Town of Hilton Head Island

Design Review Board Meeting

Tuesday, August 12, 2025, 2:30 PM

TO: Design Review Board, Town of Hilton Head Island, c/o Melissa Paul-Leto, Principal Planner of Design

Design Review Board: Final Approval
Conceptual Illustrative Enlargement Plan - Pool

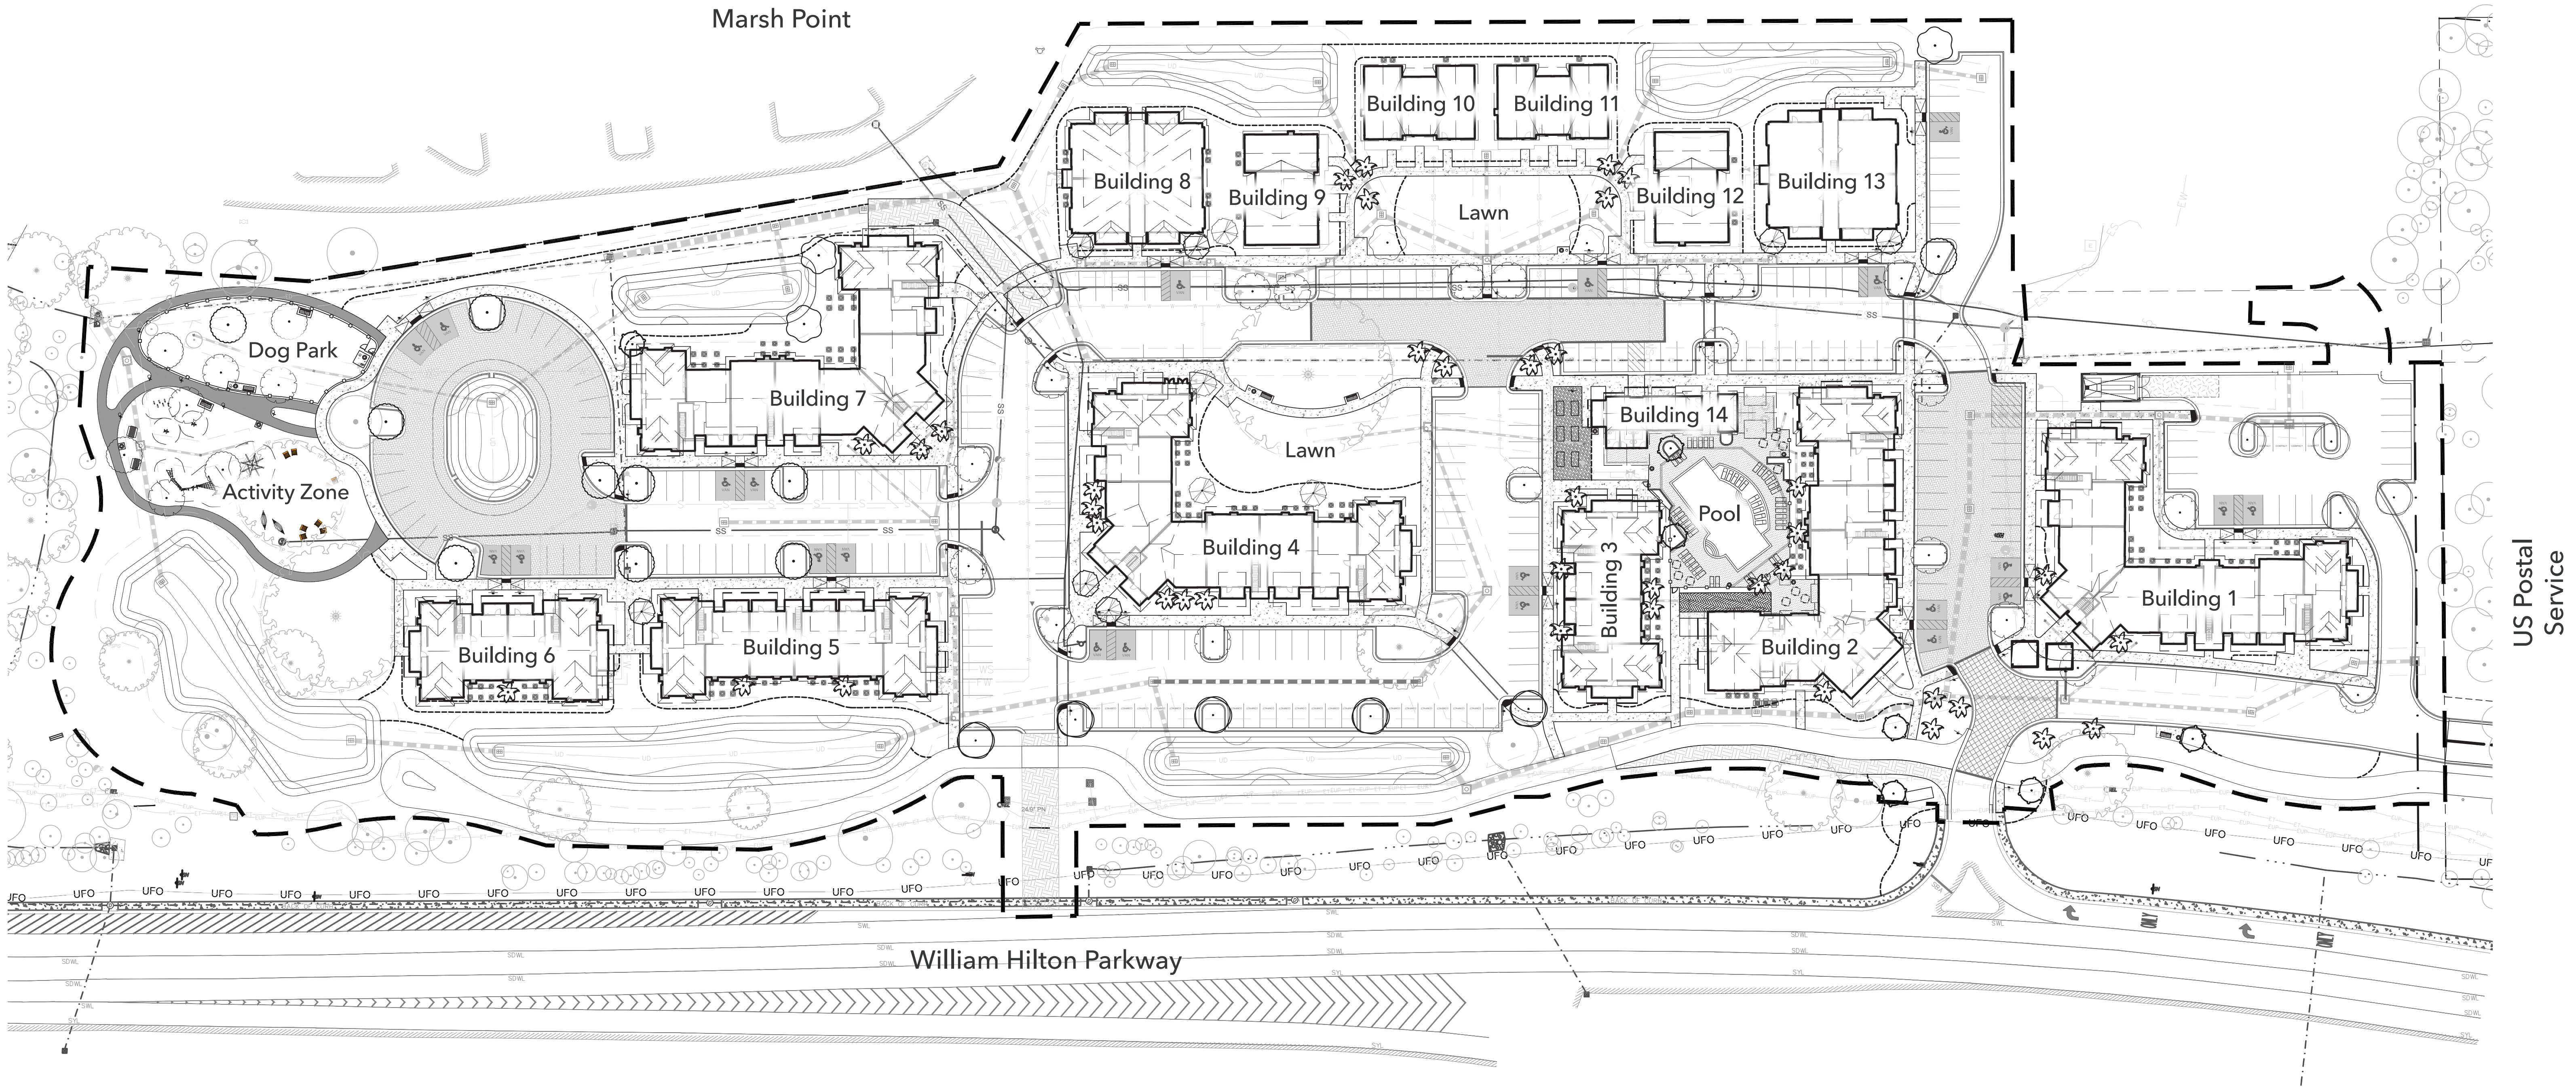
10. Provide Pool Materials

- b. While not included in the official DRB conditions of approval, there was discussion by the Board regarding the shape and features of the pool to allow for a more “family friendly” design. This, coupled with addressing comment 12 to “study the service yards and condenser locations” caused us to revisit the configuration of the pool. See the sketch below and in the drawing package. Our intent is to move in this direction with the pool designer, and the technical documents (civil and landscape) will be updated to reflect the changes once a design is confirmed. The DRB drawing package still show the earlier design for the pool as the current civil and landscape plans serve as the bases for the plans included. The new shape of the pool will be more organic and is reminiscent of some of the forms found in Gullah sweetgrass baskets. The pool will still have two headwalls to allow for lap swimming across the center part of the pool. This form also allowed us to modify the pool deck to provide more space between the pool enclosure fence and the condensers and the plantings which will provide screening for the condensers. All of this will be detailed in the final documents.

- a. A design-build pool contractor has just recently been added to the team. The final materials for the pool will be determined soon with the design-build contractor. The current plan is that the pool deck will be grey concrete, salt void finish (example below). The coping, waterline tile, and pool shell finish will be determined soon.

Revised Pool Sketch

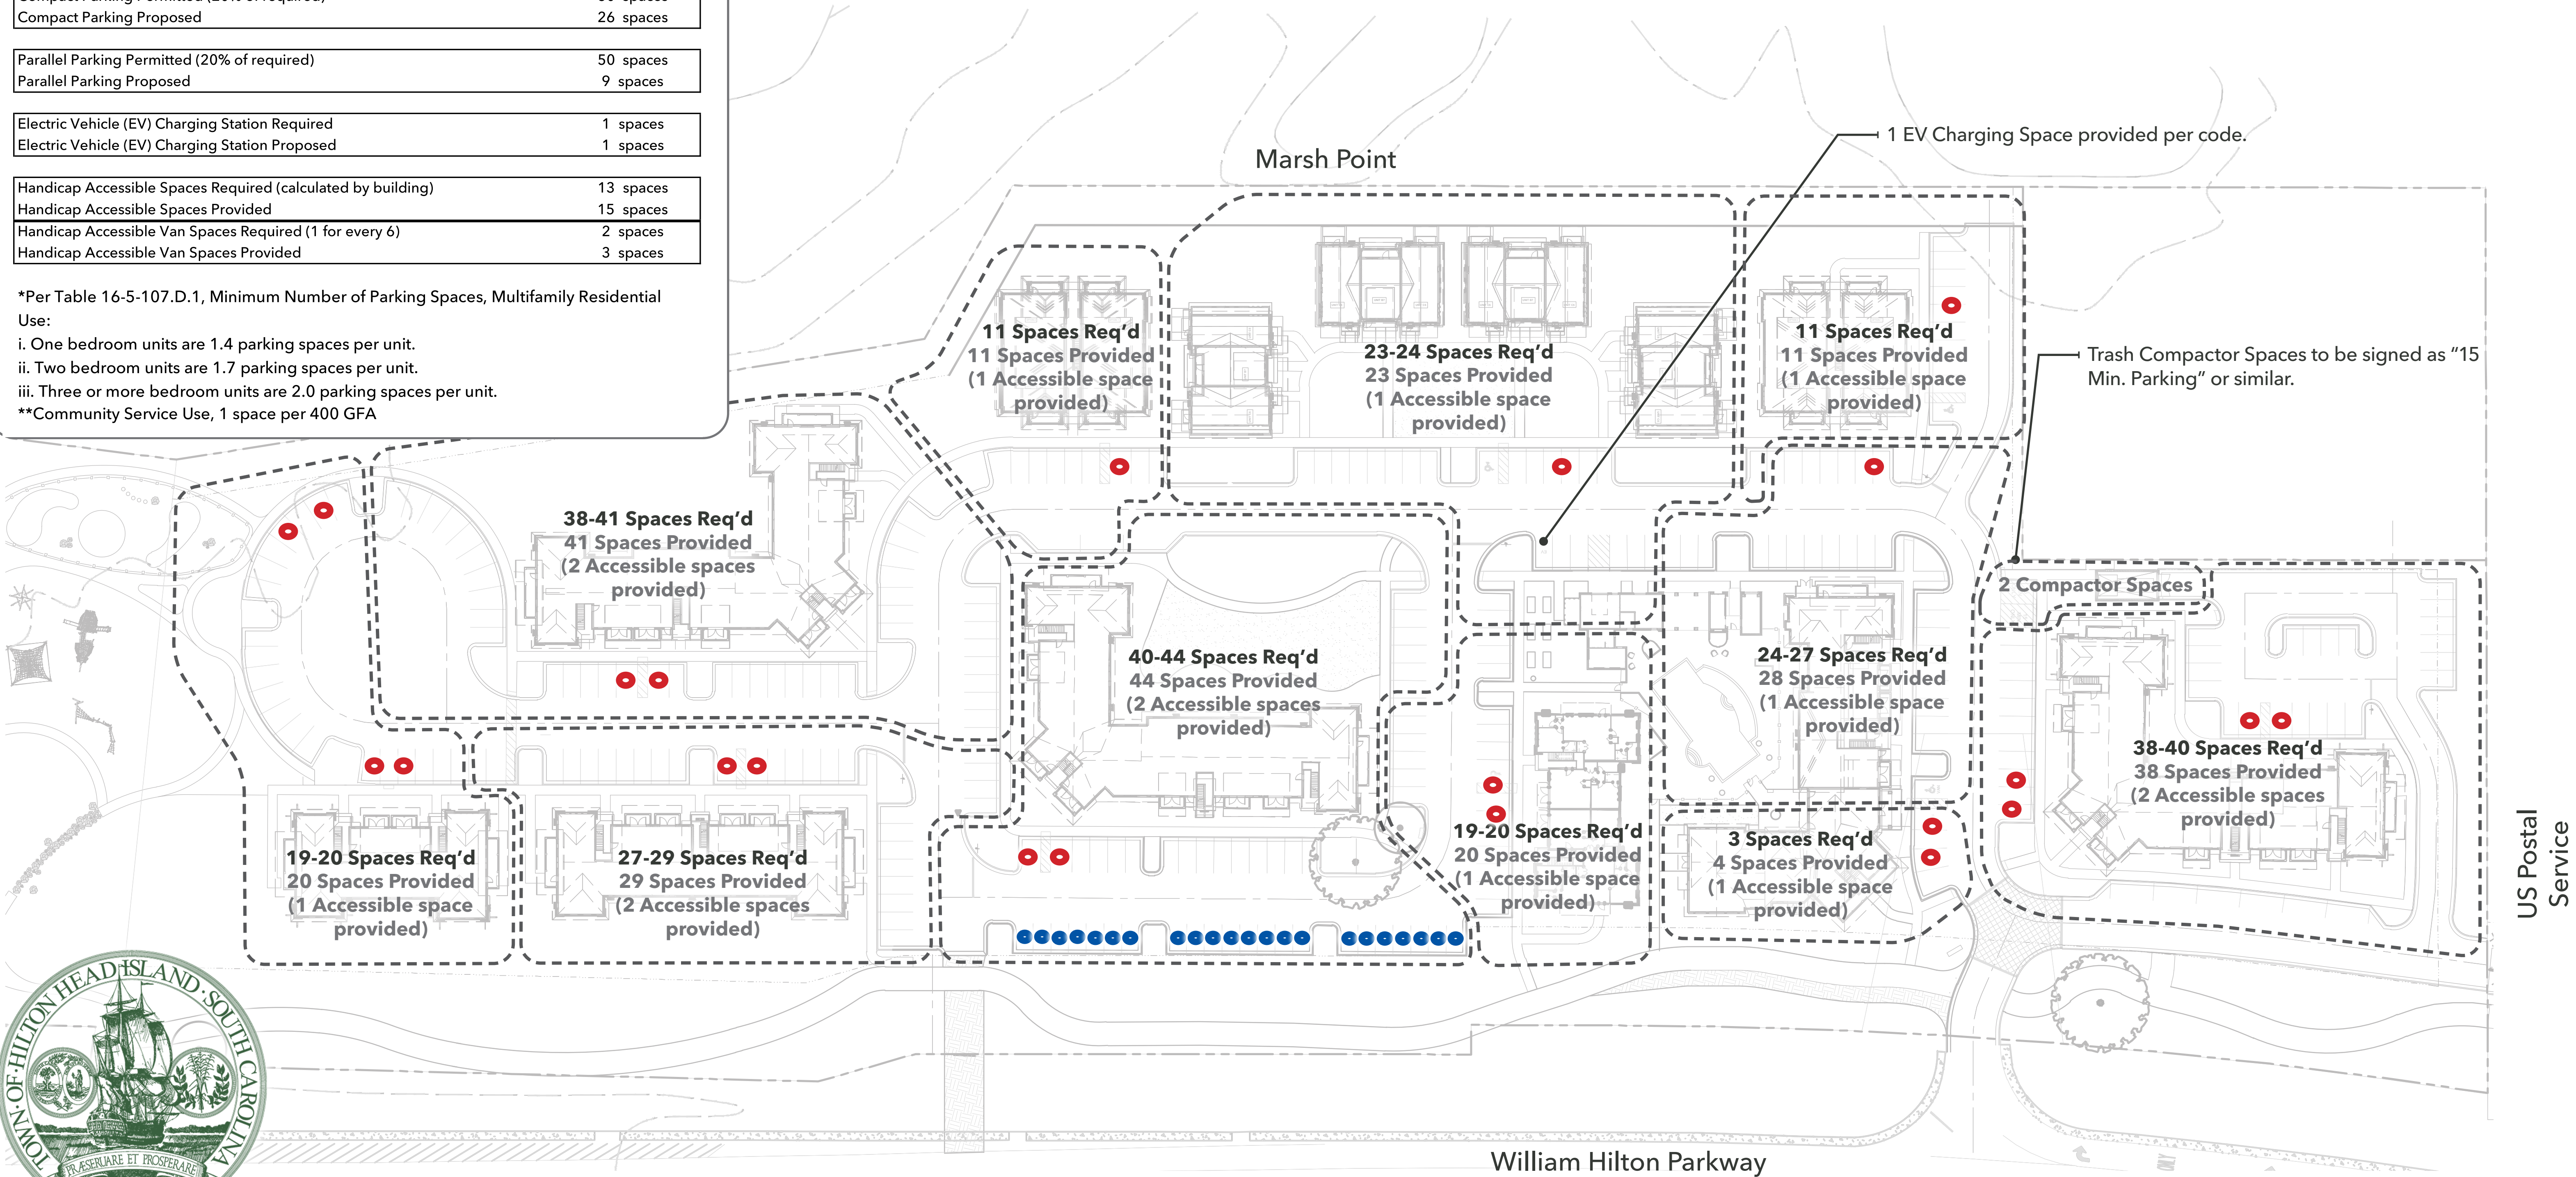
- 13. Clarify or update the floodplain zone marketing (sic) at the parking spots.
 - a. This line was included in error. There is no flood plain across the developed part of the site. Parking diagram is included on page 19.

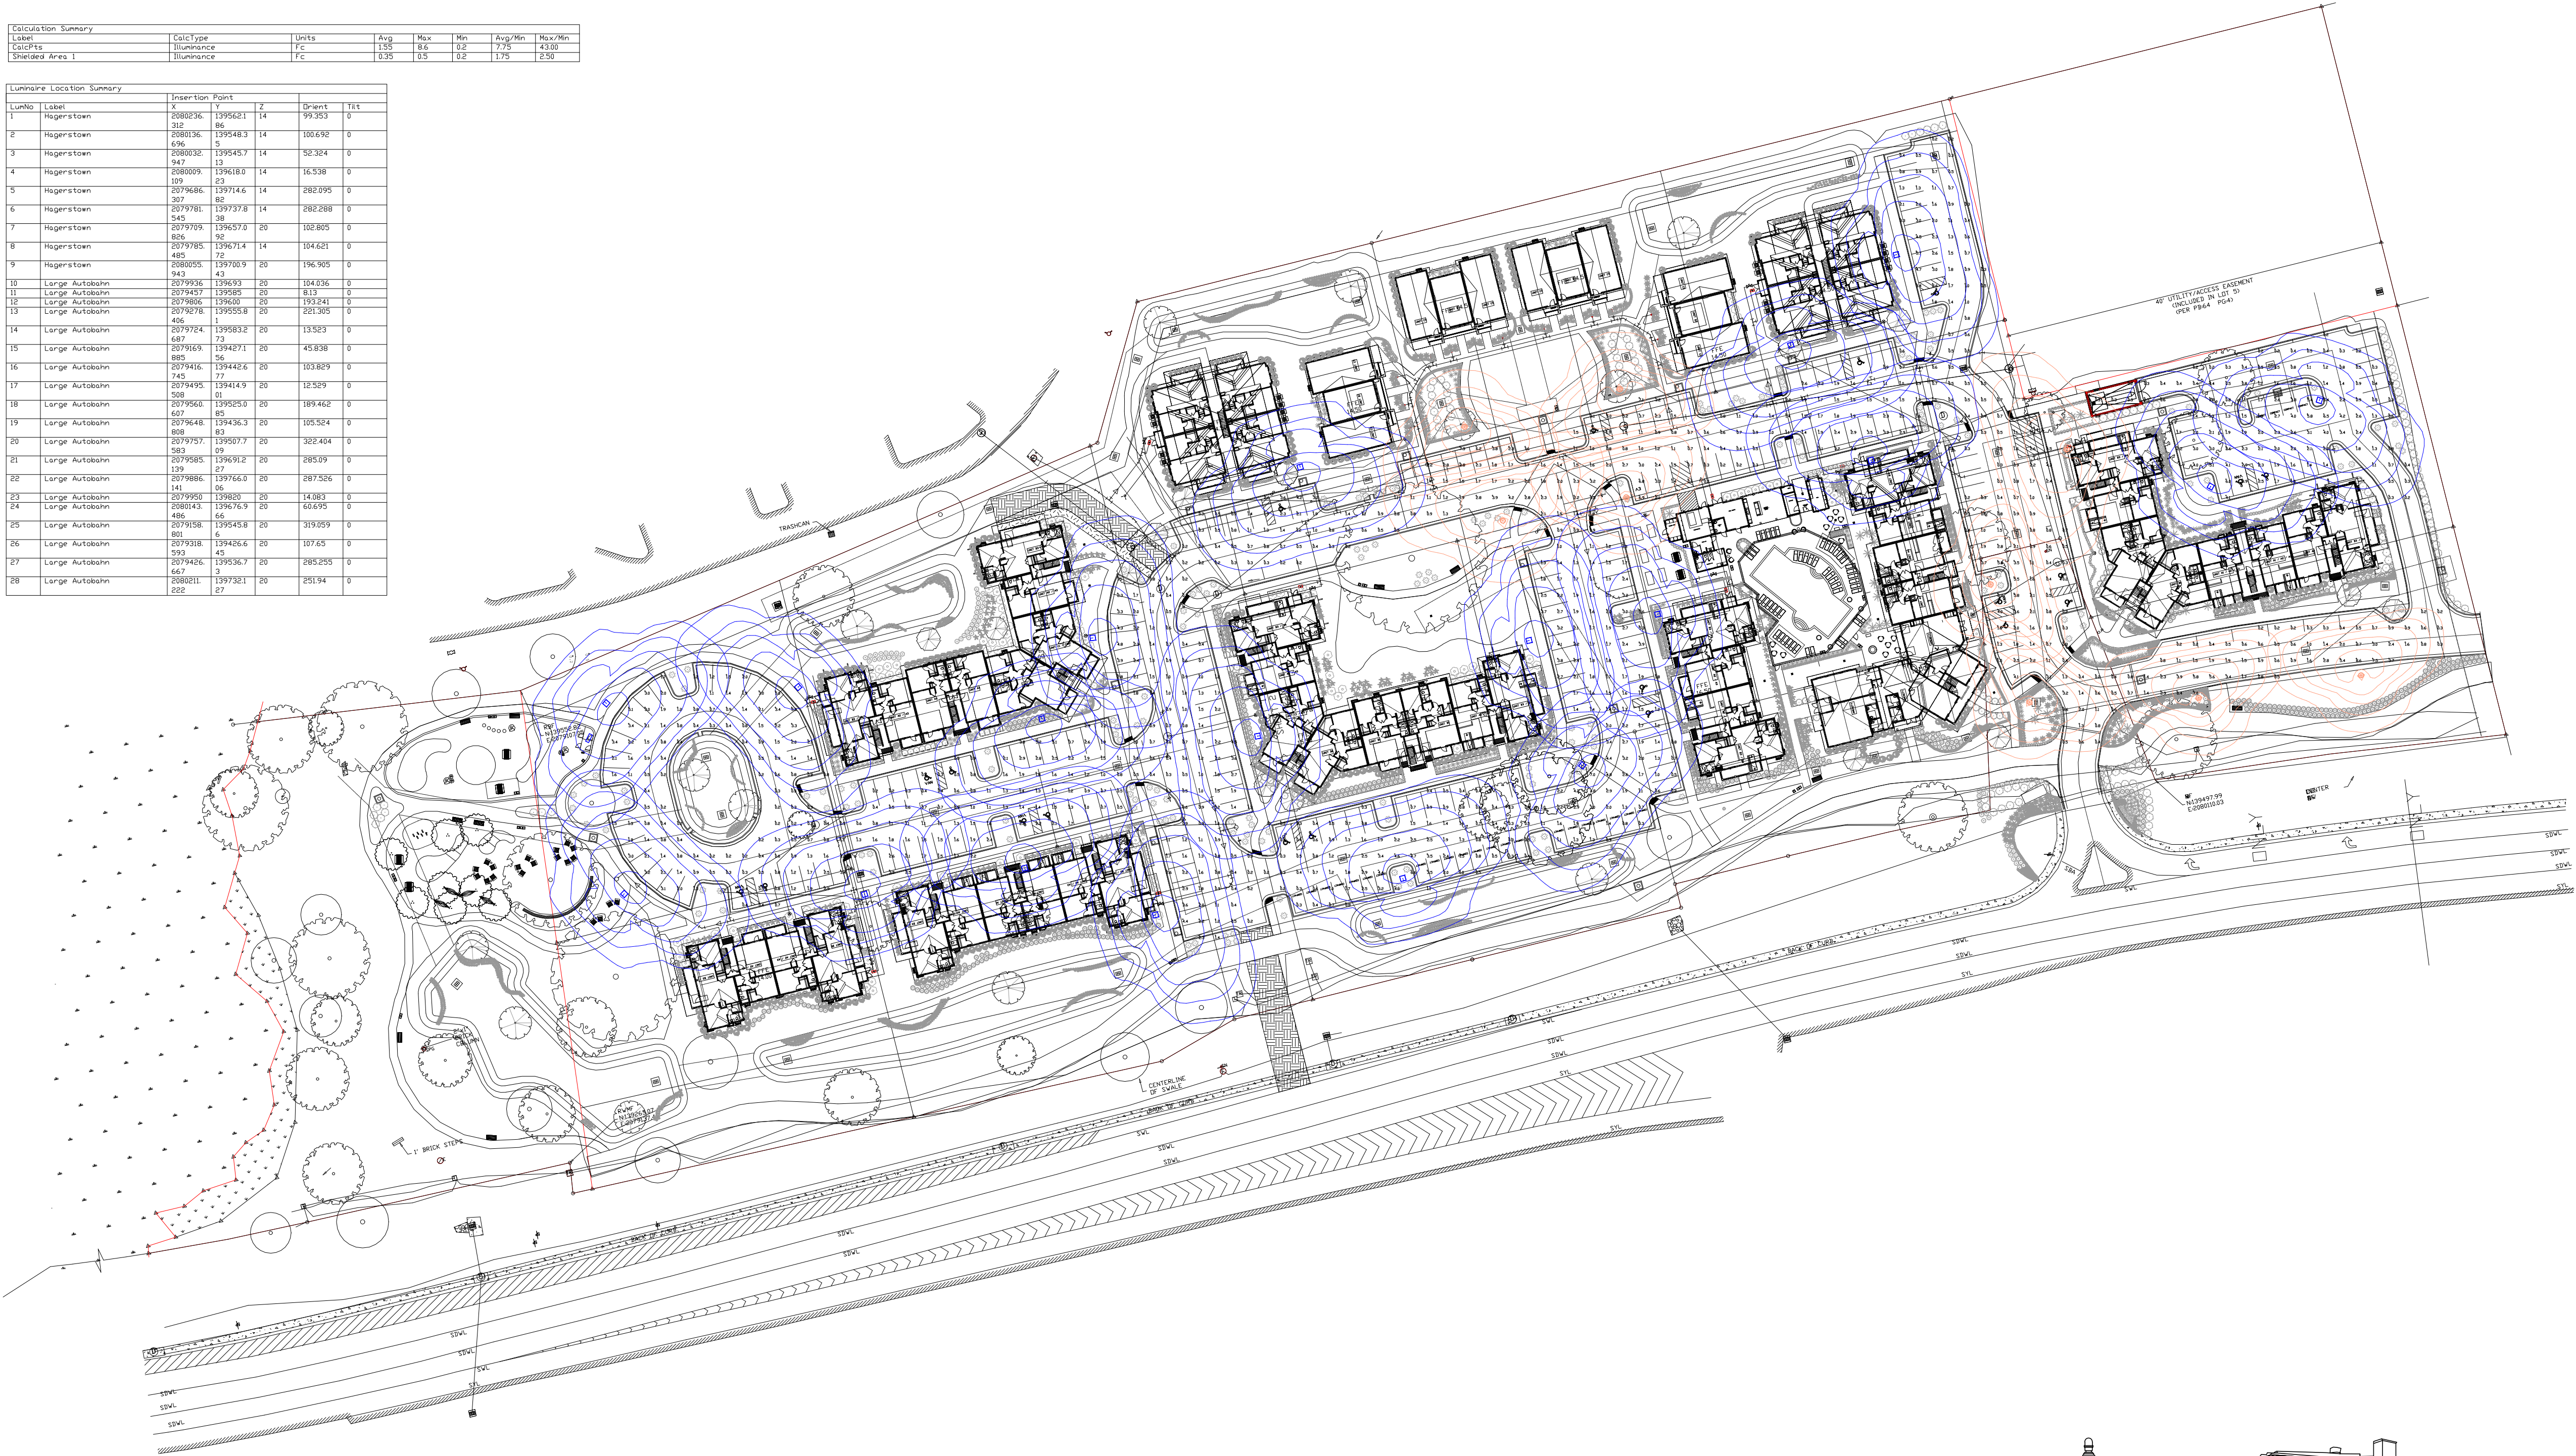
4. Study the light fixtures on the building, site, and pathways
- a. The exterior lighting for the site and buildings are being provided by two different sources. The lighting for the parking areas and drives will be provided by Palmetto Electric. The on-building lighting and a limited amount of landscape lighting will be provided by the developer. An overall site lighting plan indicating locations of the site and building lighting is included within, see pages 24-29. Cutsheets for the lighting are included on pages 22 & 23.

- i. The parking and drive aisle fixtures are provided by Palmetto Electric include two fixtures. The Hagerstown fixture is the more decorative of the two fixtures used. These are utilized along the entrance drive from both Highway 278, the drive from the USPS site, at the core of the site at Central Green. The balance of parking and drives lighting utilizes the Large Autobahn fixture. The Site Lighting Plan prepared by Palmetto Electric indicates the lighting pattern for the Hagerstown fixtures in **ORANGE** on their plan. The lighting pattern for the Large Autobahn fixtures is shown in **BLUE** on their plan.
